NINE MILE POINT NUCLEAR STATION

TITLE: DRYWELL COOLING SYSTEM

ATTACHMENT 6
LESSON PLAN TEMPORARY/PUBLICATION/ADDENDUM CHANGE FORM

Modification Title: Ductwork and Air Flow Changes for 2DRS-UC1A through 1D

DOCUMENT NUMBERS IMPACTED LSK-22-22

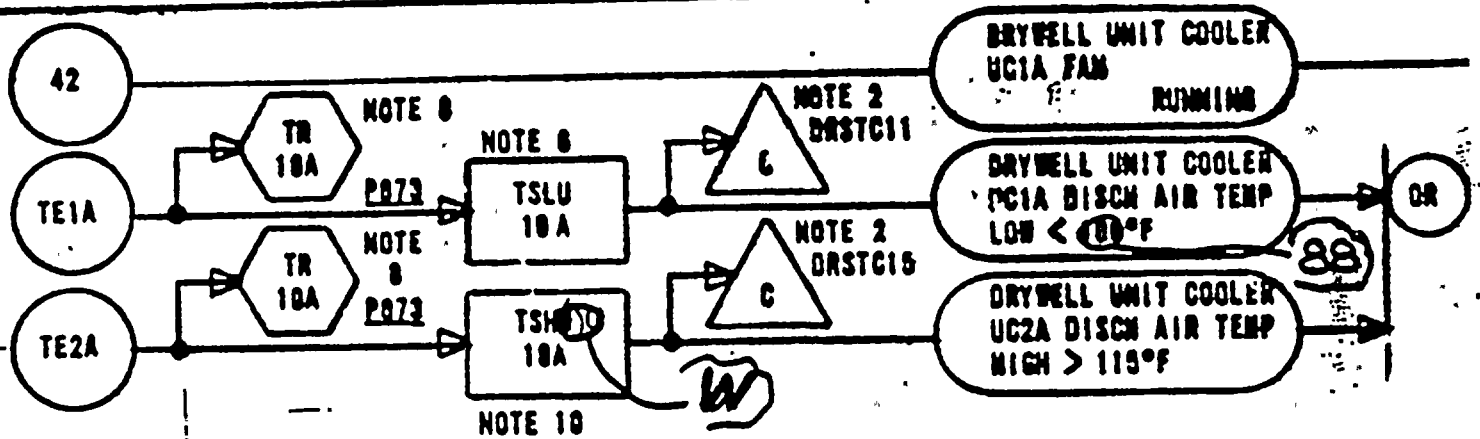
REVISE! LSK-22-22 as shown
Below!
